Proposal for editorial corrections to ECE/TRANS/WP.29/GRPE/2018/4

Submitted by the Informal Working Group on Worldwide harmonized Light vehicles Test Procedure (WLTP)*

Amendment 1 to global technical regulation No. 19 on Evaporative emission test procedure for the Worldwide harmonized Light vehicles Test Procedure (WLTP EVAP)

Figure A1/4
Test procedure flow charts *Flow of the test procedure*

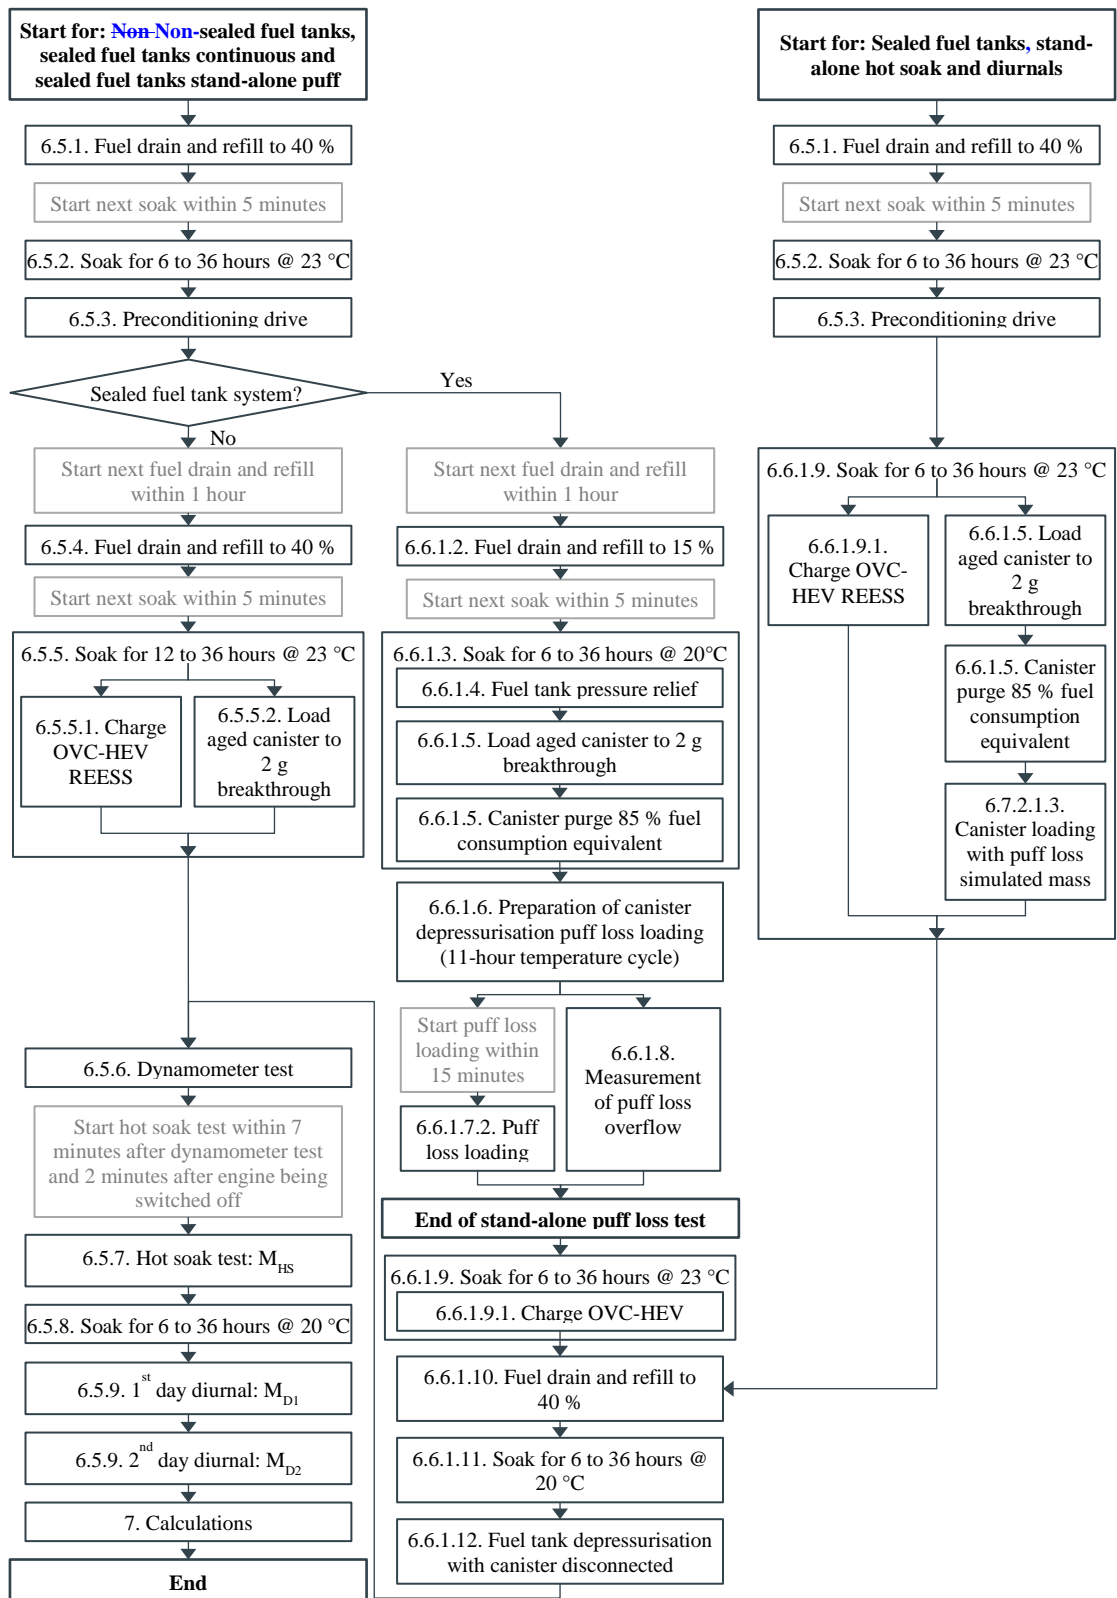
- 6.5. ~~Test~~ **Continuous test** procedure for non-sealed fuel tank systems
- 6.5.1. Fuel drain and refill
- The fuel tank of the vehicle shall be emptied. This shall be done so as not to abnormally purge or abnormally load the evaporative control devices fitted to the vehicle. Removal of the fuel cap is normally sufficient to achieve this. The fuel tank shall be refilled with reference fuel at a temperature of 18 °C ±2 °C to 40 ±2 per cent of its nominal capacity.
